Revised
4-29-91

No. 91-4

A. 815471A3 BRAVO SHIFT CABLE REPLACEMENT KIT

70377

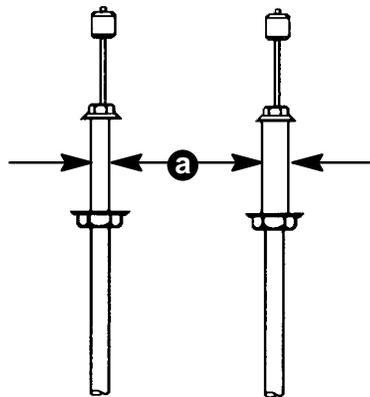
All Bravo Transom Assemblies serial number OD542204 and prior require enlarging the bell housing shift cable retainer hole from 3/8" (.375) (9.525mm) to 7/16" (.437) (11.113mm) explained following.

This shift cable is designed for use as a replacement for all previous style shift cables on all Bravo Transom Assemblies.

1. Remove Stern Drive and Shift Cable as outlined in the appropriate sections of the Bravo Stern Drive Unit, Service Manual.
2. Compare the shift cable that was removed from the unit with the replacement shift cable.
 - a. If diameter "a" is equal on both the removed cable, and the replacement cable, install the replacement cable as outlined in the Bravo Stern Drive Unit, Service Manual. Disregard all of the following instructions.
 - b. If the diameter "a" is larger on the replacement shift cable than on the removed shift cable, proceed with the following instructions.

70376

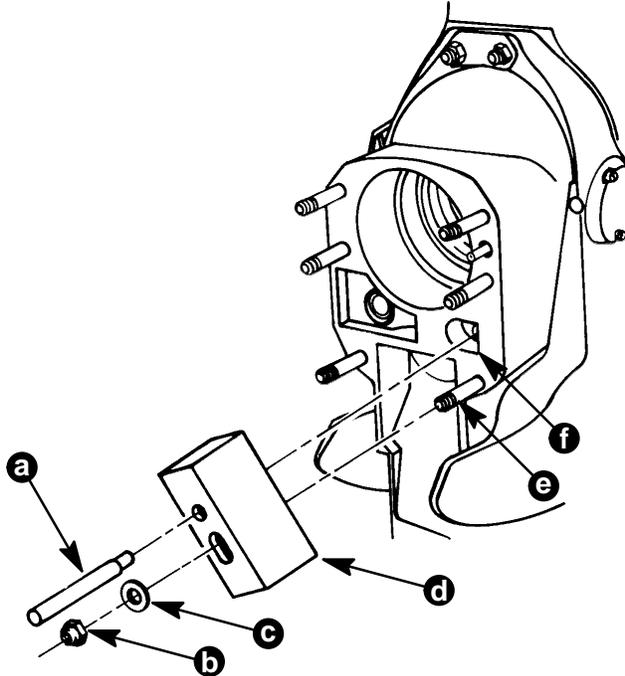
1. Assemble the slotted hole of the drill bushing tool over the lowest stud closest to the Bell Housing shift cable bore.
2. Assemble the alignment rod through the round 7/16 in. hole of the bushing tool and into the Bell Housing shift cable bore. Make sure that it is seated fully into the bore.
3. Clamp these into place using one of the nuts and washers that hold the Stern Drive unit to the Bell Housing.

70378

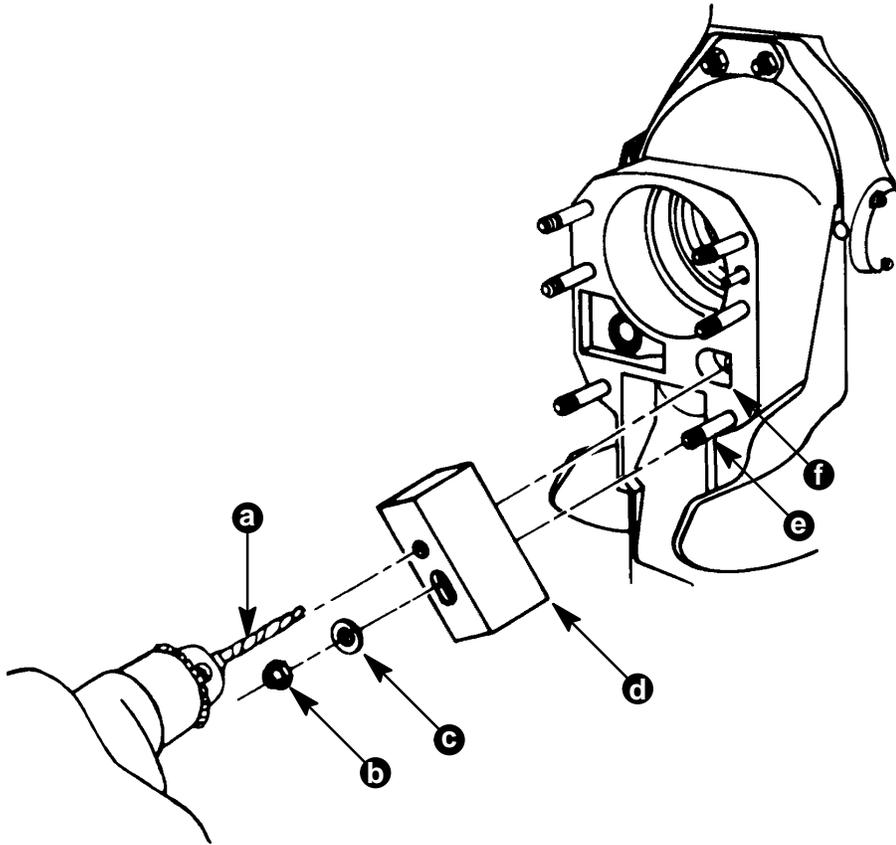
4. Using the 7/16 in. drill provided with the service tool kit, P/N 91-818836A-1, drill through the 7/16 in. hole of the bushing tool and through the Bell Housing shift cable bore.

The drill used to drill this hole must be sharp, without nicks, straight, and have a 118° point. Failure to use the proper drill may cause a rough surface in the newly drilled hole. This could cause water to leak through the Bell Housing and into the Drive Shaft Housing, which could cause premature failure to the shift components.
